SUBJECT: CALVERT CLIFFS NUCLEAR POWER PLANT, UNIT NO. 1 - AMENDMENT  
RE: PRESSURE-TEMPERATURE LIMITS EVALUATION (TAC NO. MA7220)

AMENDMENT TO FACILITY OPERATING LICENSE

Amendment No. 234  
License No. DPR-53

SAFETY EVALUATION BY THE OFFICE OF NUCLEAR REACTOR REGULATION  
RELATED TO AMENDMENT NO. 234 TO FACILITY OPERATING LICENSE NO. DPR-53

Figure 3.4.3-1  
Calvert Cliffs Unit 1 Heatup Curve, for Fluence  $\leq 4.49 \times 10^{19}$  n/cm<sup>2</sup>  
Reactor Coolant System Pressure Temperature Limits

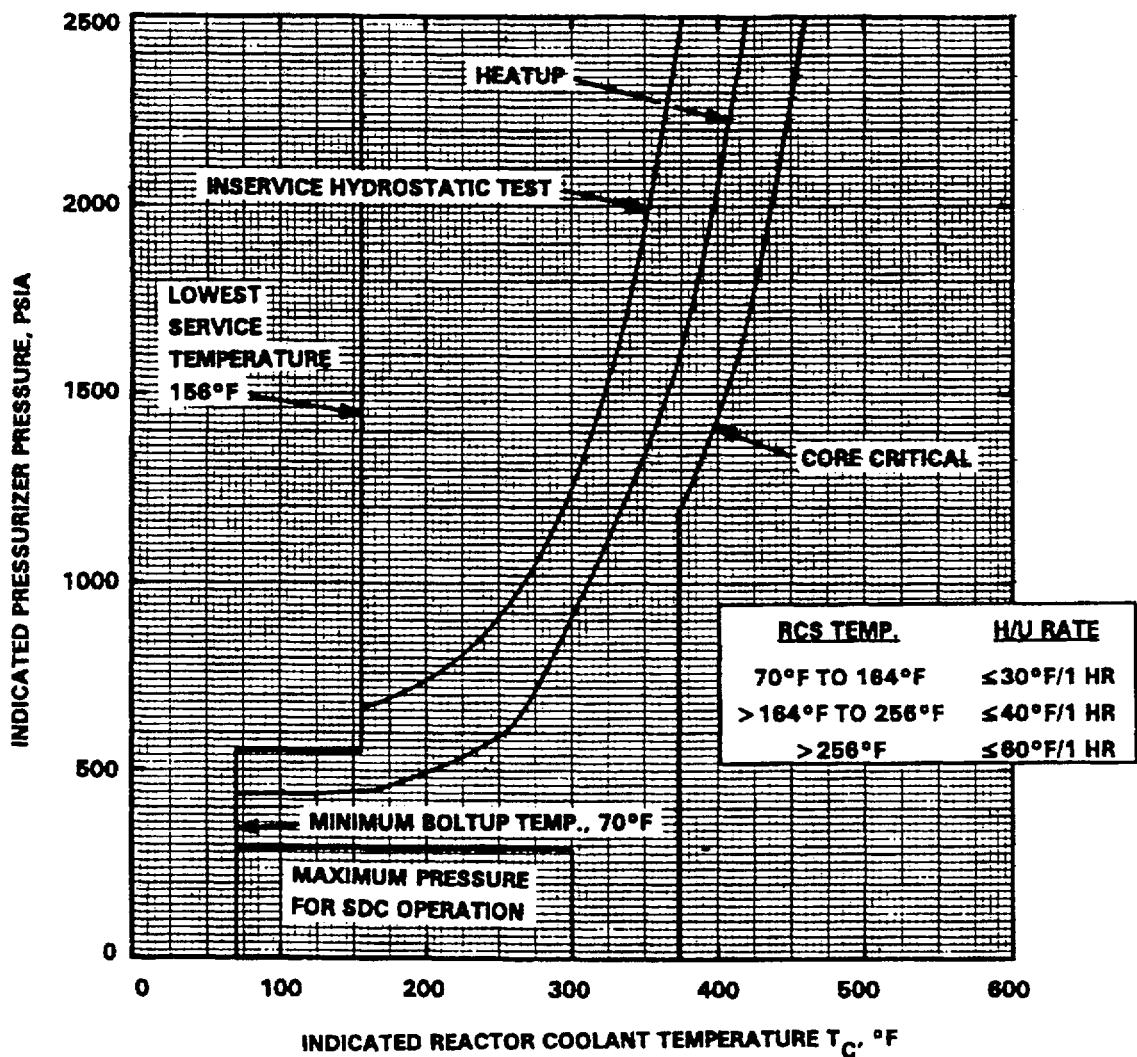
The amendment incorporates a change in the pressure-temperature (P-T) limit curves in the Calvert Cliffs Unit 1 Technical Specifications. Baltimore Gas and Electric Company (BGE) changed the fluence level for which the curves are valid from  $2.61 \times 10^{19}$  n/cm<sup>2</sup> to  $4.49 \times 10^{19}$  n/cm<sup>2</sup>.

Using the material properties of the new PTS critical welds 3-203-A, B, and C, BGE justified using a fluence value of  $4.49 \times 10^{19}$  n/cm<sup>2</sup> for the Unit 1 TS P-T curves. BGE obtained results of 229.3 °F and 181 °F for the ARTs at 1/4T and 3/4T, respectively.

The staff performed an independent calculation of the ART values using the new fluence for the limiting material using the methodology in RG 1.99, Revision 2. The staff's calculated ART value for the limiting material agreed with the licensee's calculated ART value. On the basis of these calculations, the staff determined that the licensee's proposed fluence is acceptable.
